GLASTAR/SPORTSMAN SERVICE BULLETIN 51

Subject: Inspection of the 100-0640-009 angle stock supplied in GlaStar and Sportsman Kits.

Applicability: All Sportsman and GlaStar fuselage kits shipped between March 2005 and June 2005.

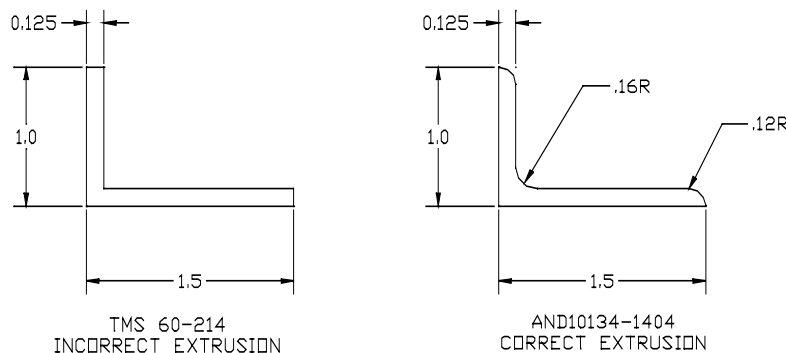
These angle fittings are made from a 1" x 1-1/2" x .125" angle, which is controlled per the AND10134-1404 standard. This number is typically stamped on the extrusion. If it is not visibly marked, then you should perform a check to verify your extruded angle is per the AND10134-1404 profile shown.

We have determined that improper angle material was supplied to Glasair Aviation on March 29, 2005. The improper angle material specified a different extrusion number - TMS 60-214 – which is identified on the material. The figure below illustrates the difference between the correct and incorrect material sections

If you have received the incorrect angle (TMS 60-214) with your kit, please contact Glasair Aviation for replacement material at no charge if complied by August 1, 2005. The part number for the replacement material is the same (100-0640-009).

You should discard all parts made with the improper material and replace them with parts made from the correct AND10134-1404 extrusion.
